# Buildings 1 & 2

JANUARY 12, 2022

COMPARISON:  
AUGUST 10, 2021 SPECIAL PERMIT PRESENTATION  
& JANUARY 5, 2022 SCHEMATIC PLANS PRESENTATION

Rendered Site Plan with Level 1  
JANUARY 5, 2022

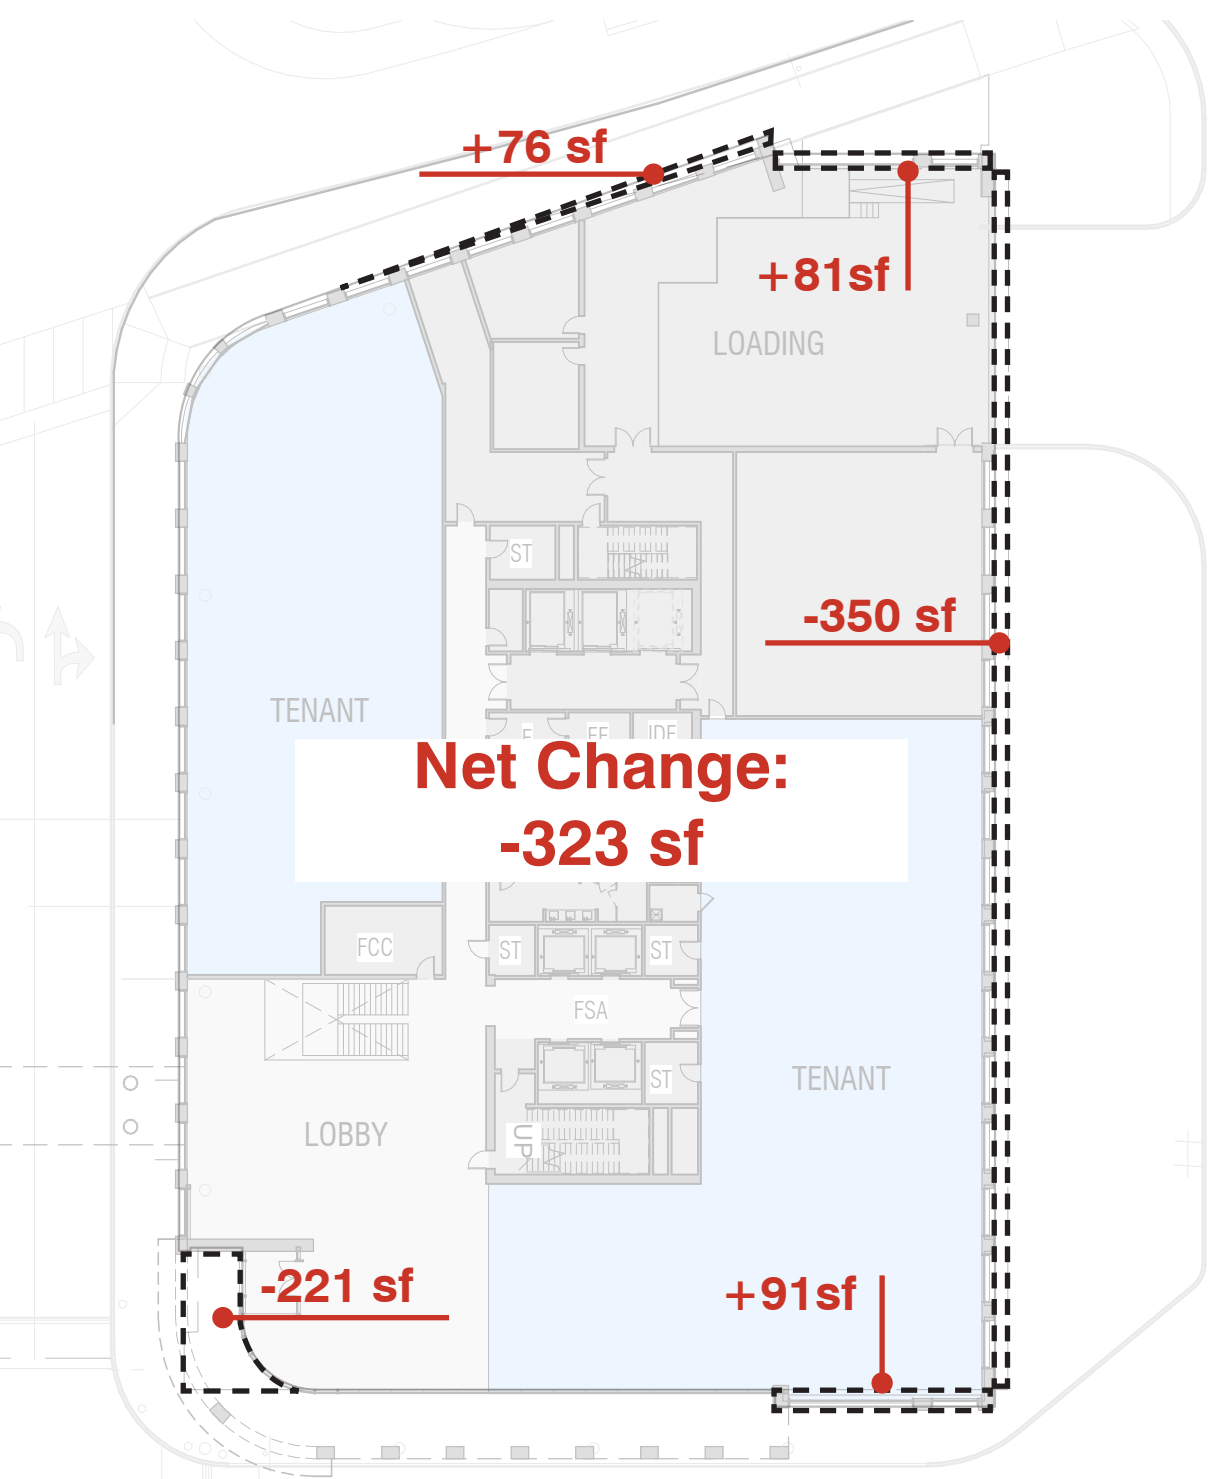
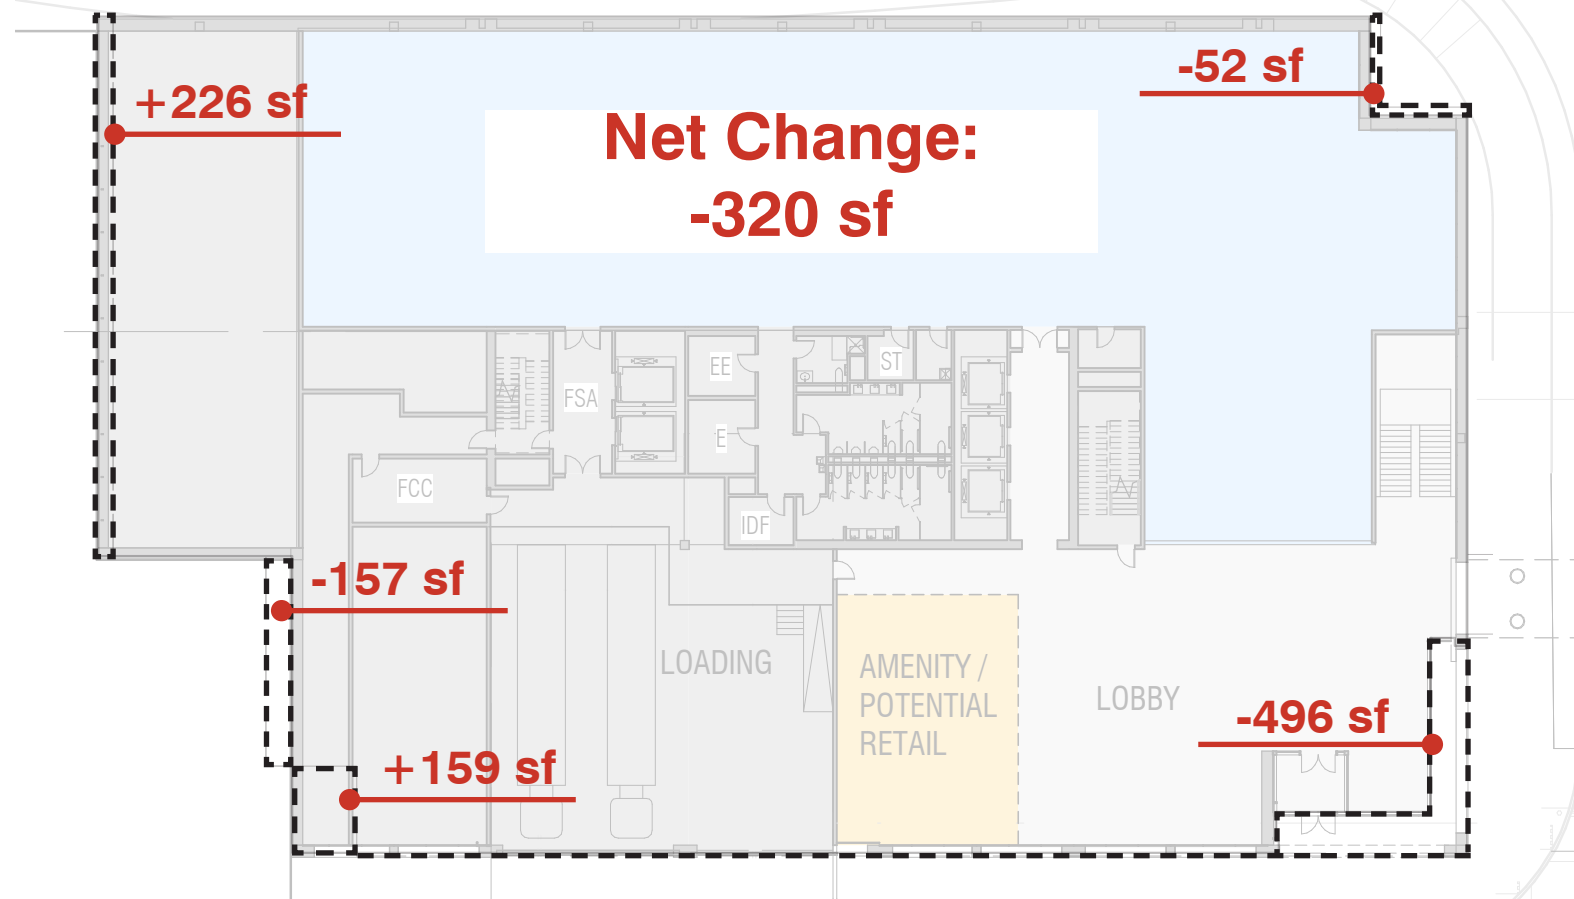
- introduction of double-height terraces and building amenity spaces at Level 3

- expansion of Building 2 penthouse enclosure
- introduction of serpentine perforated-metal enclosure at Building 2 upper penthouse

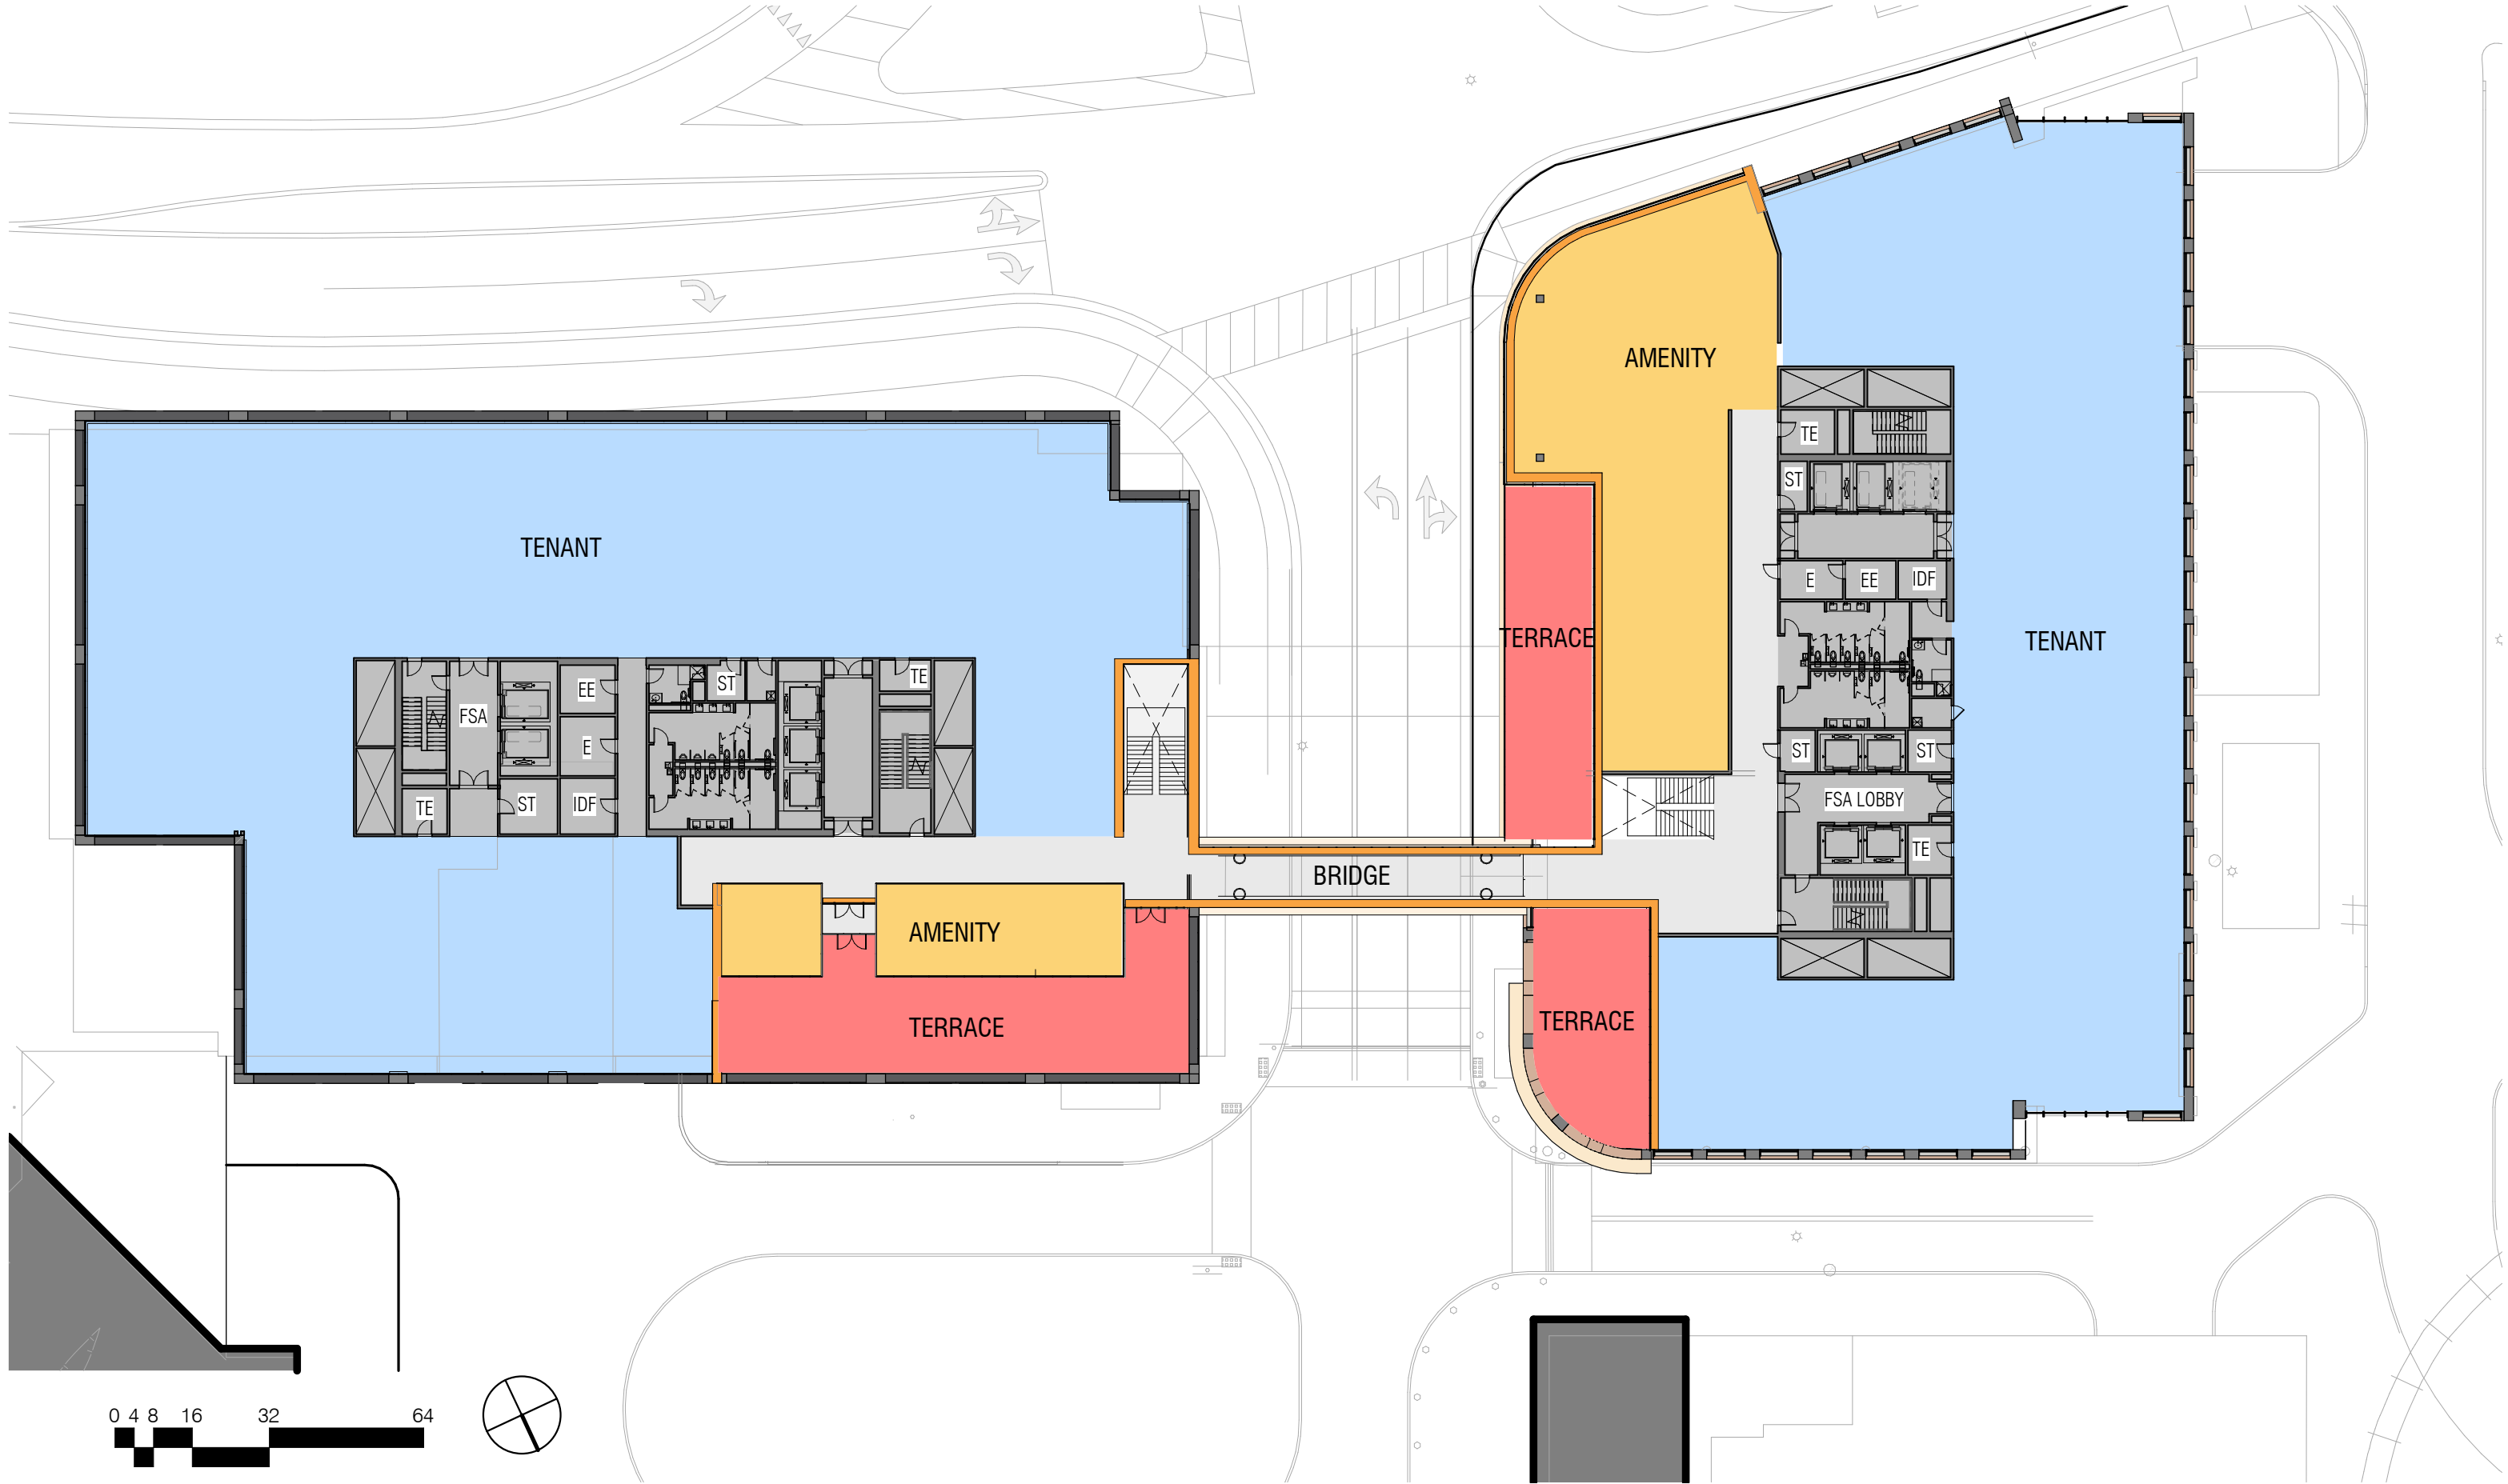
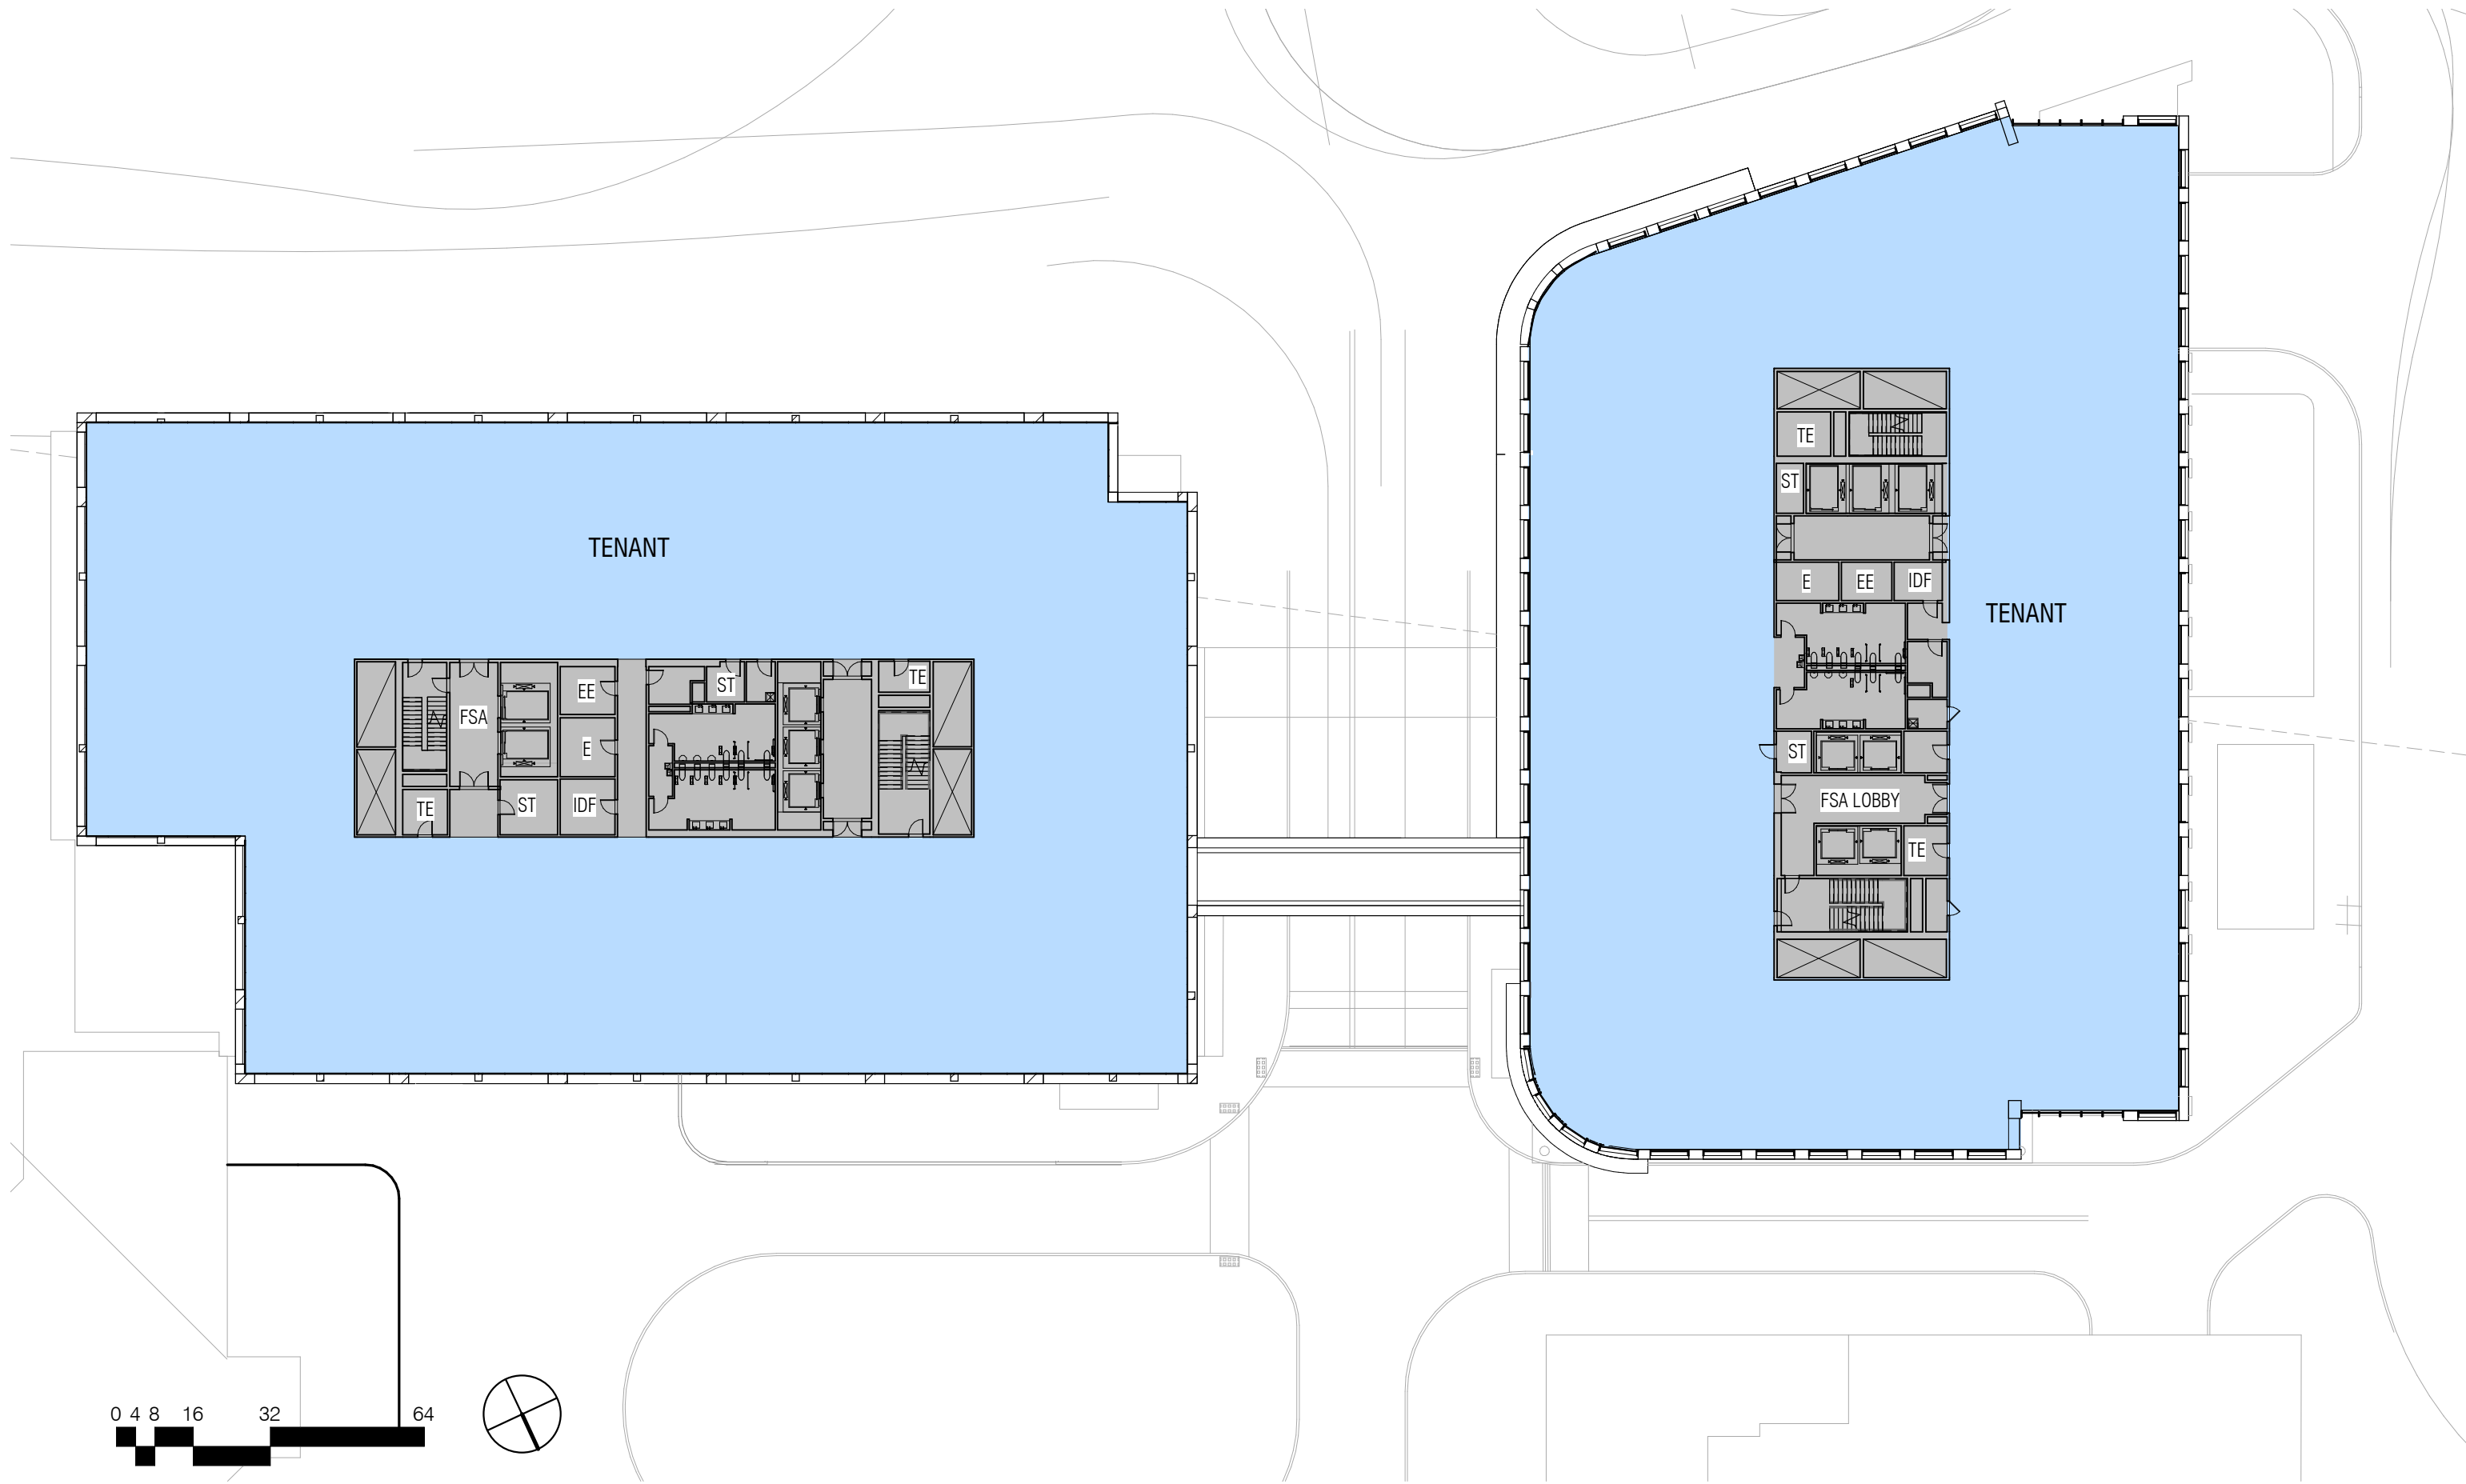
- Level 1 footprint adjustments result in minor reduction in site coverage at each building
